Access Compliance Report Public Rights-of-Way (Curb Ramps)

Main Street: JEFFERSON_ST Cross Street: ROOSEVELT_AVE Location: NE

ADA ID: RPRK211001142043 Ramp Type: Type 1 - Perpendicular Diagonal Initial Pass/Fail: Fail Overall Compliance: No Severity Score: 2

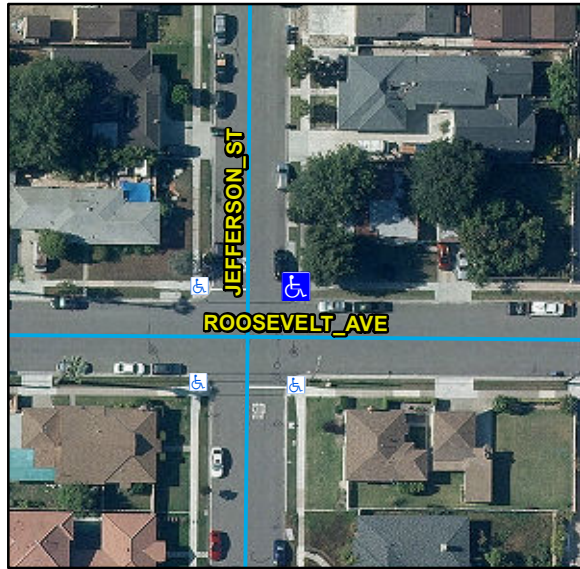
R304.2.2, R304.5.3, STD 1115

Remove & Replace Curb Ramp With Two New Directional Ramps or Equivalent.
